UNIVERSITY OF KENTUCKY Purchasing Division

CCK-2602-22

ADDENDUM # 1

ADDENDUM #1 – BID PACKAGE #2

A2.3A 1/8" = 1'-0" TRUE NORTH PLAN NORTH

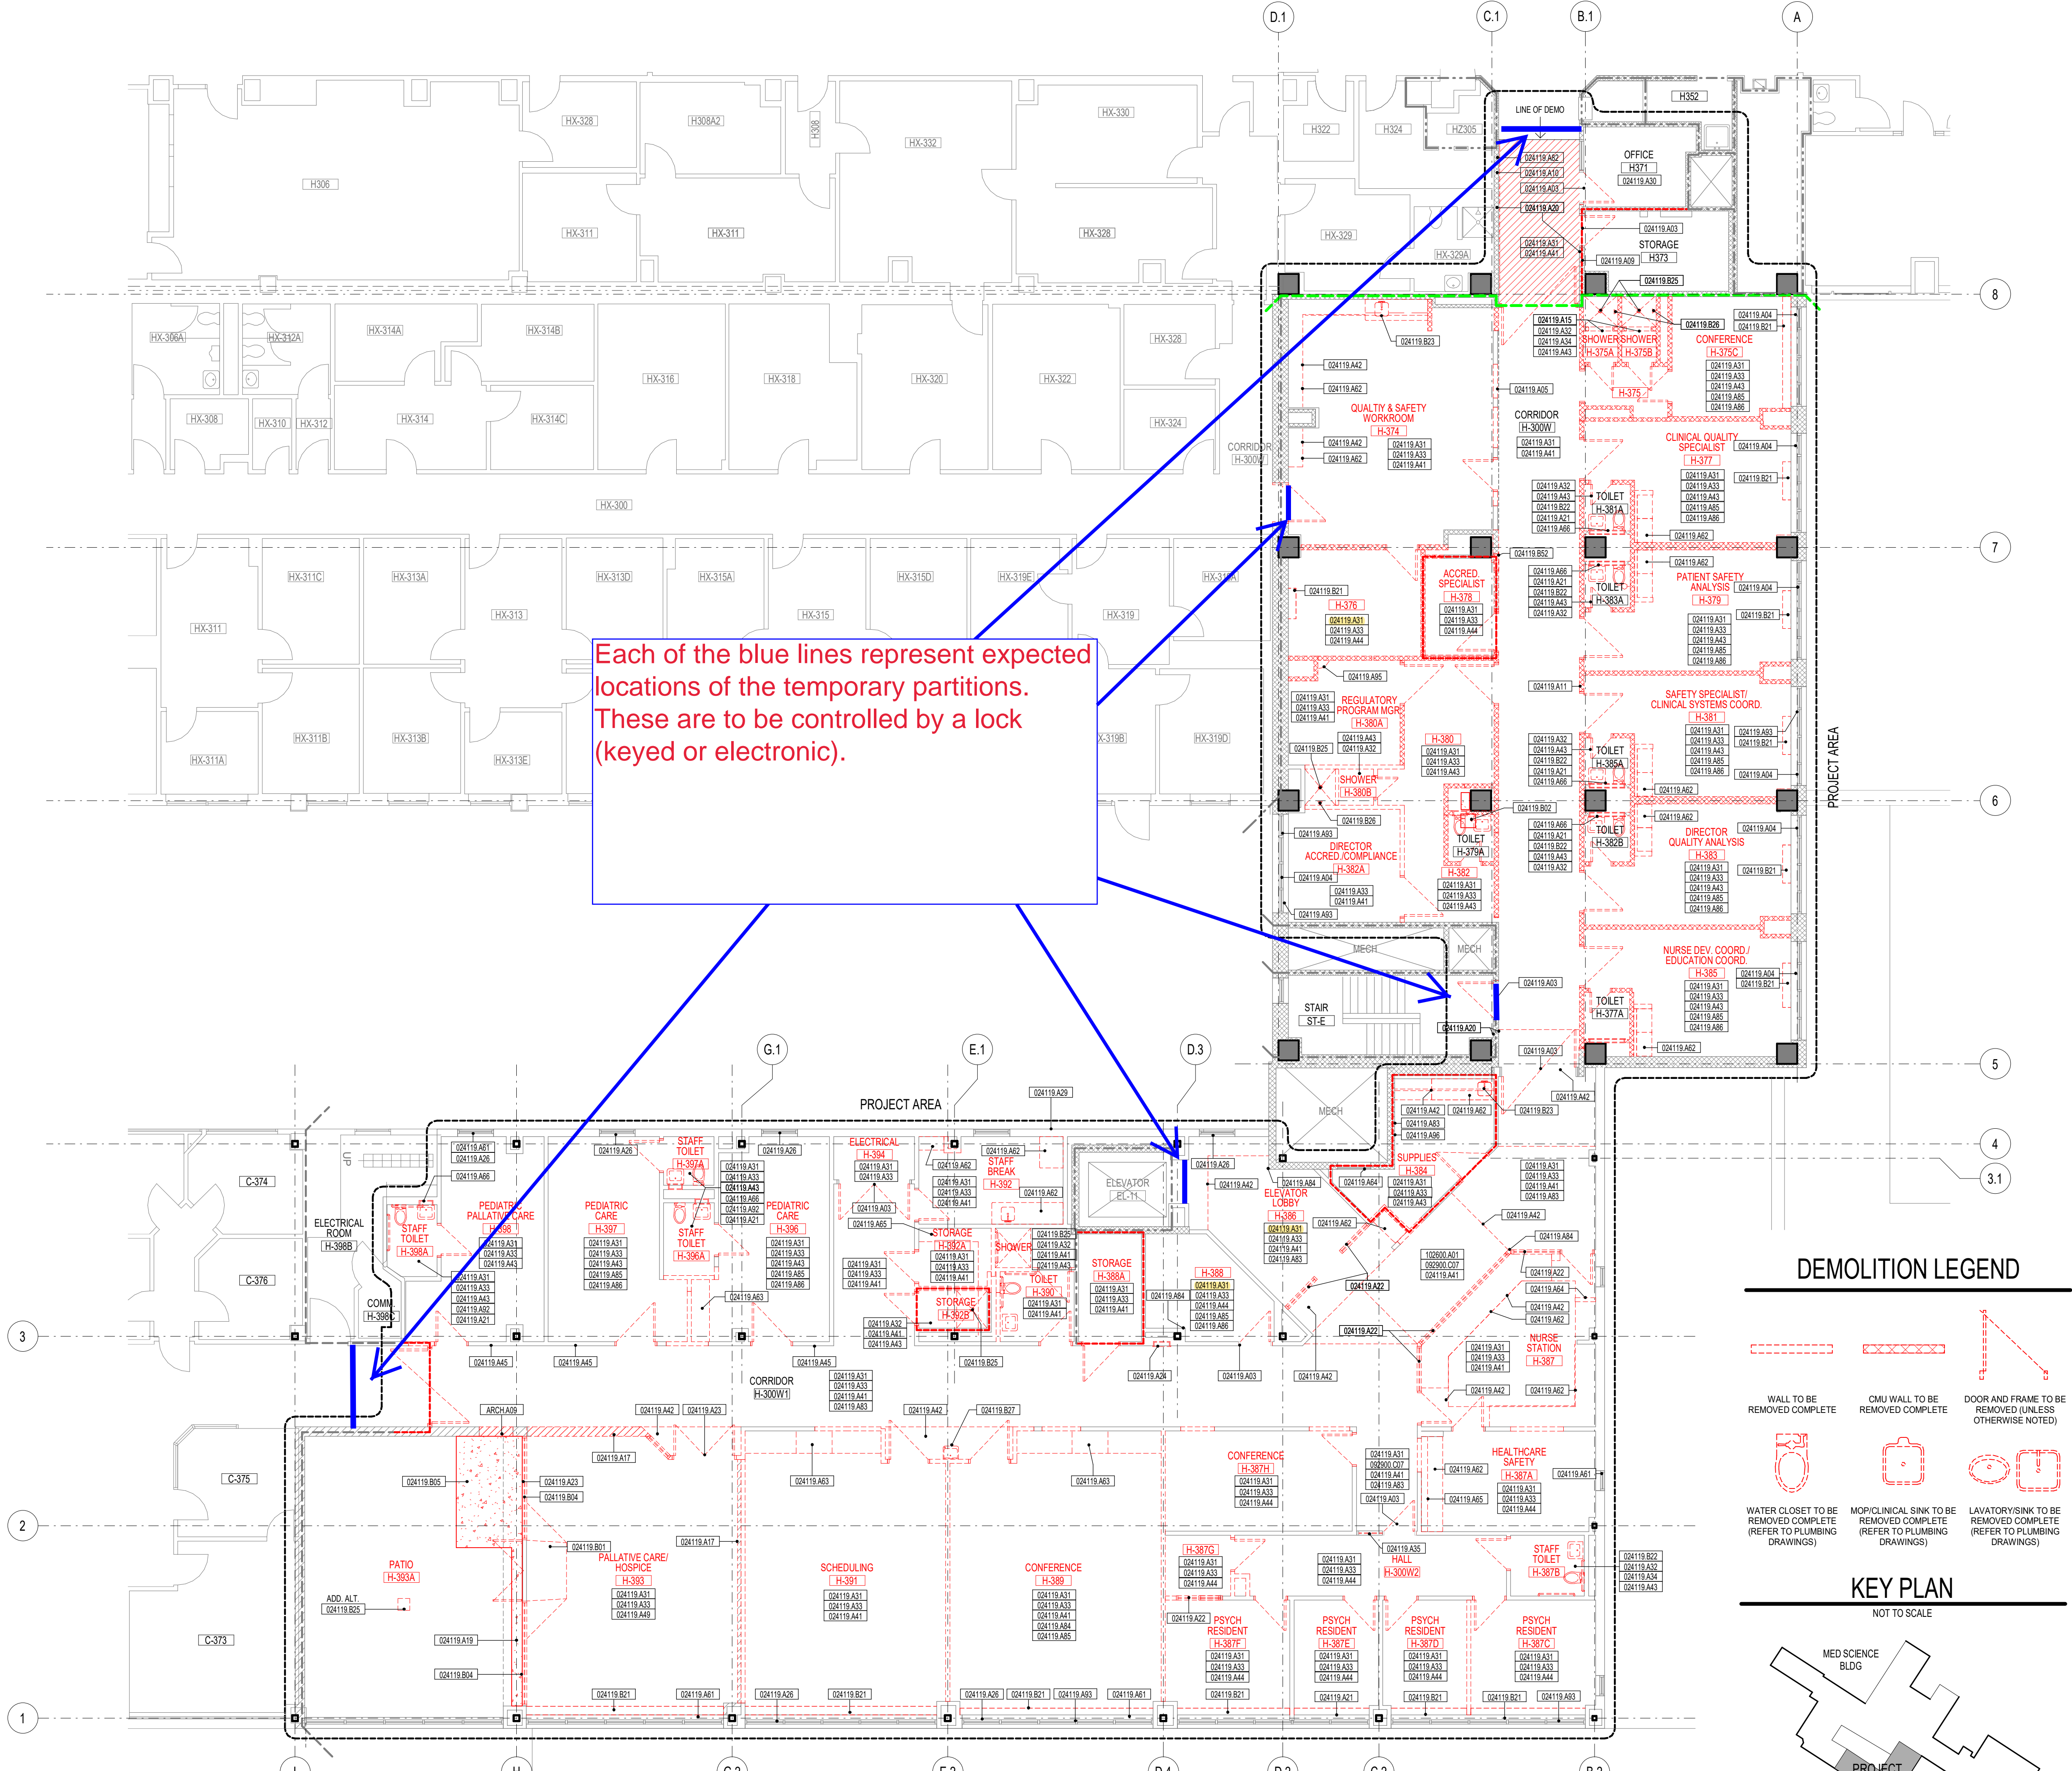
- 3.10 Reference:** Sheet A2.3.A
- A. **Clarification:** Remove existing flooring, wall base and ceiling tiles at Rec Therapist H03.306. (No revised sheet included)

01 ENLARGED THIRD FLOOR PLAN - AREA 'A1'
A4.3.A.1 1/4" = 1'-0"
TRUE NORTH PLAN NORTH

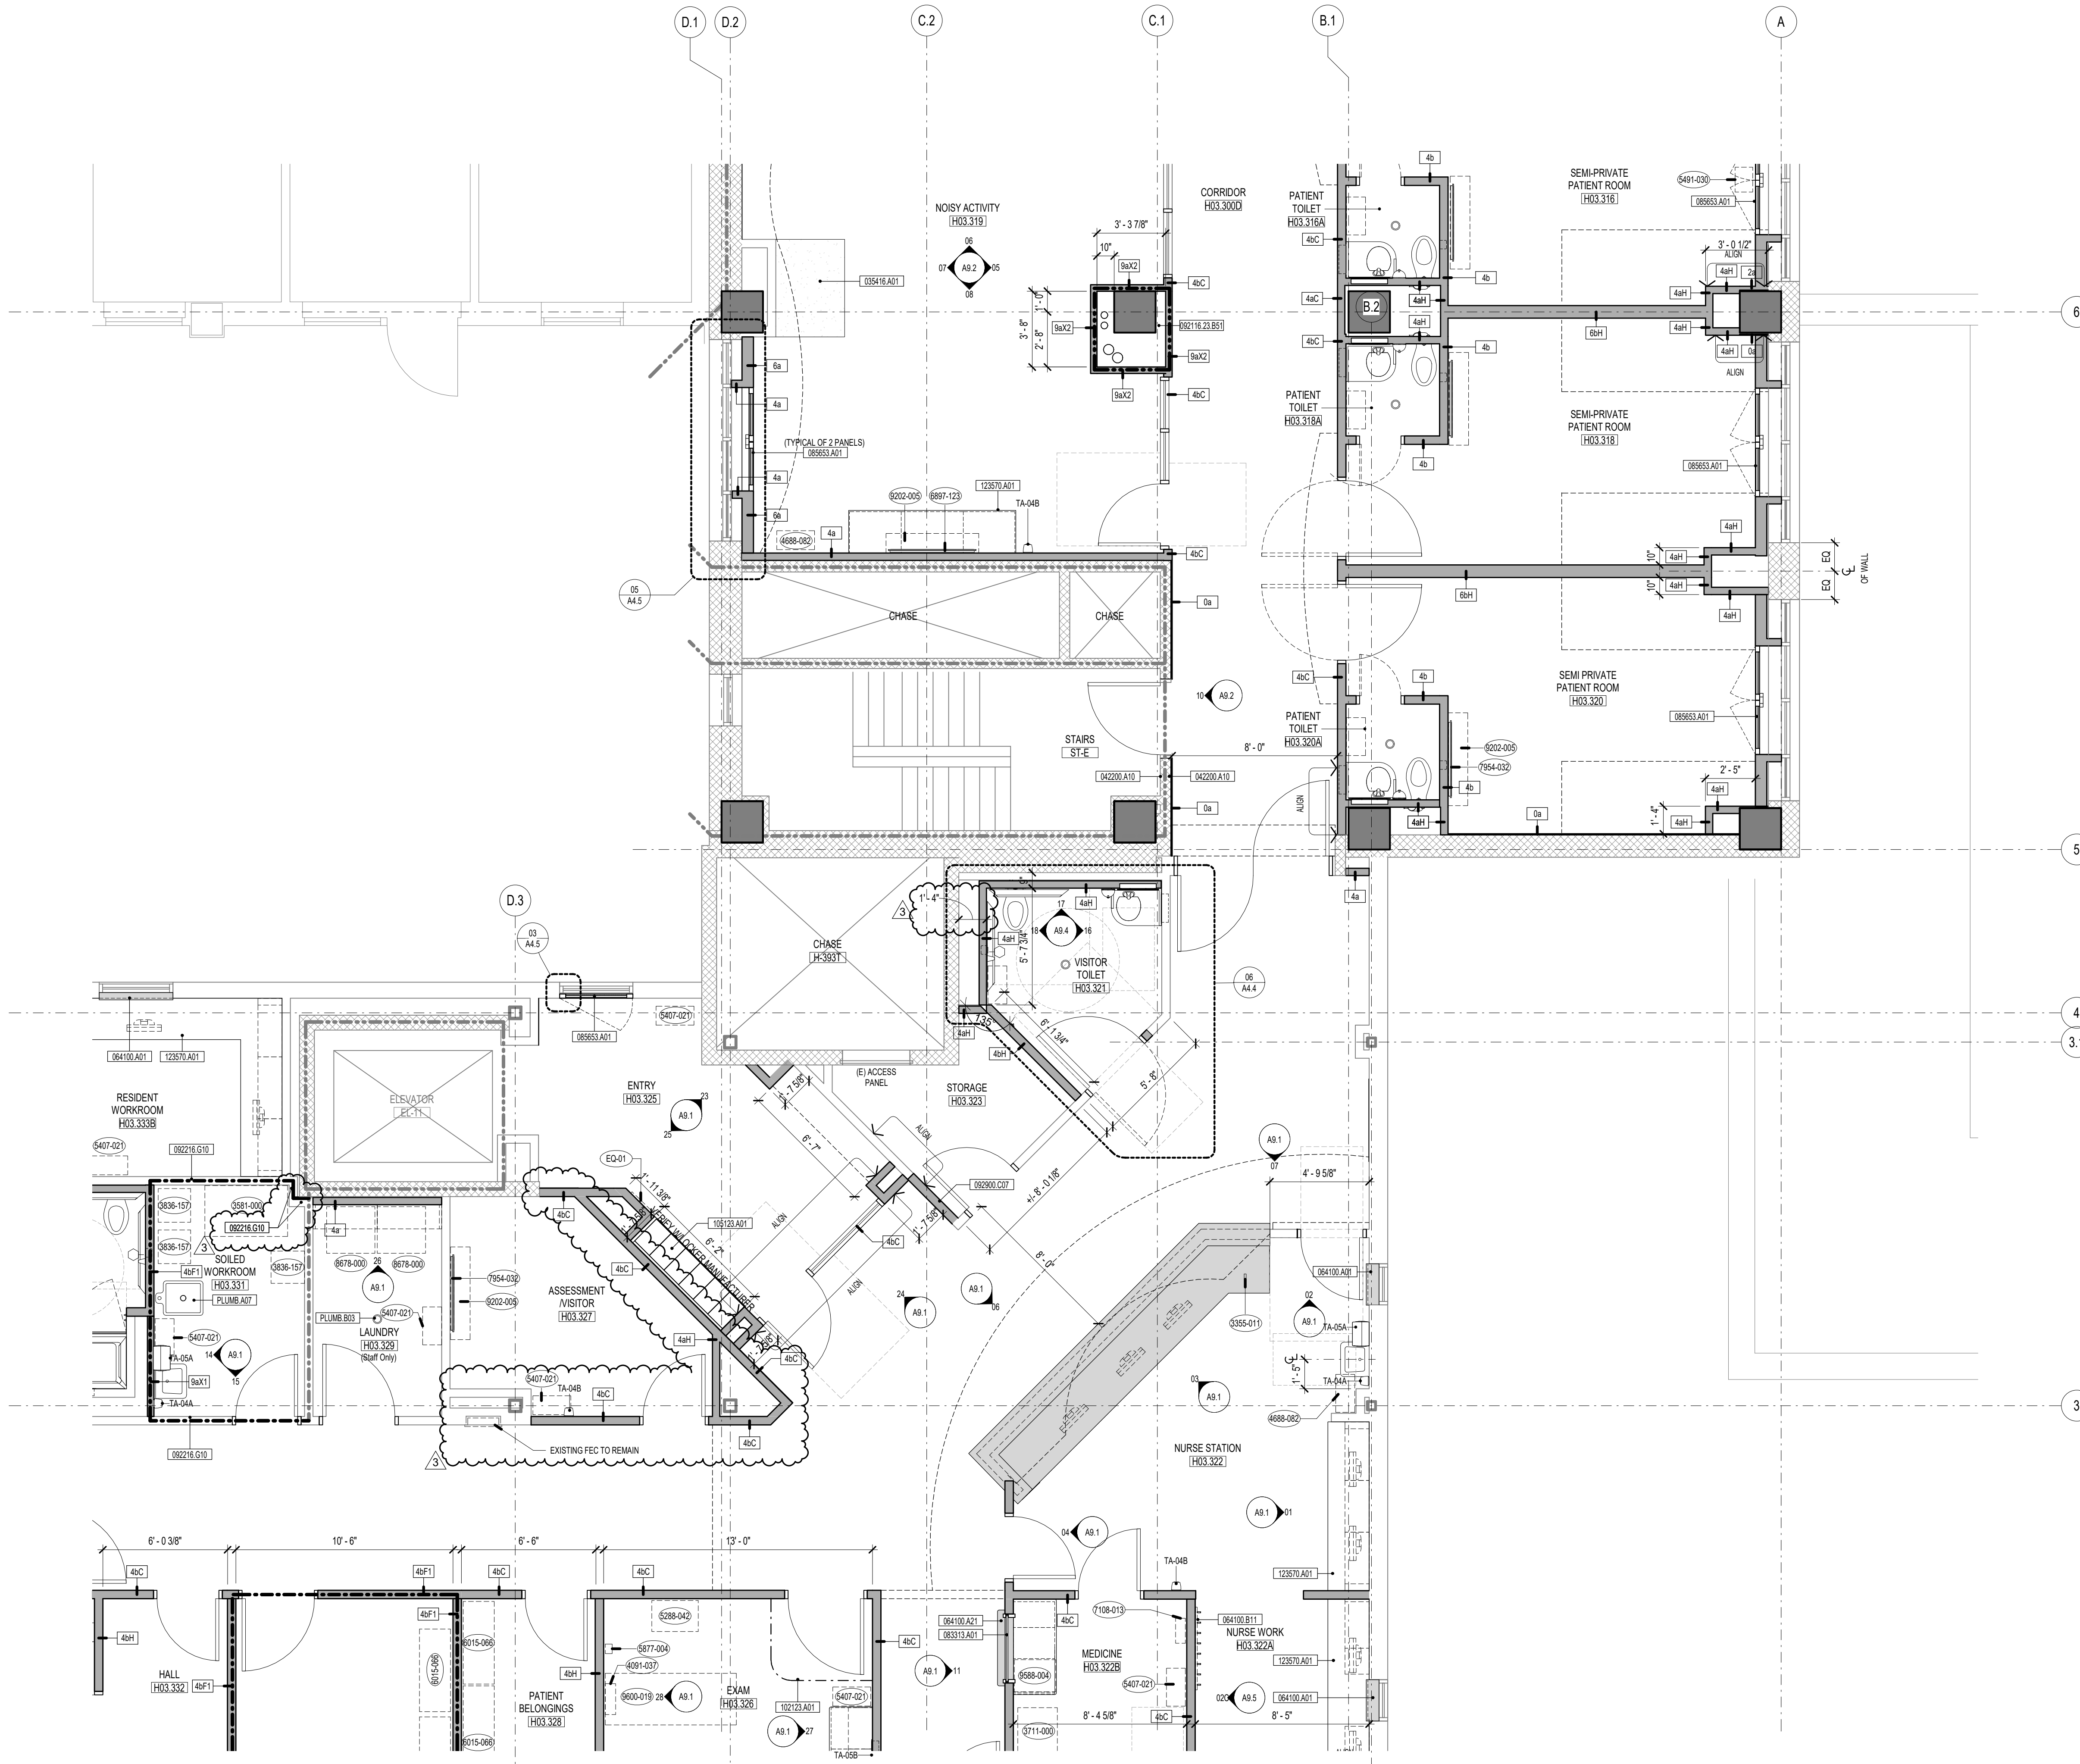
- 3.11 Reference:** Sheet A4.3.A.1, A4.3.A.2, A4.3.A.3, and A4.3.A.4 Enlarged Floor Plans
- A. **Clarification:** Added new walls added at/near Ante Room H03.313, Assessment H03.327, and Hall H03.324 where additional demolition work was needed.
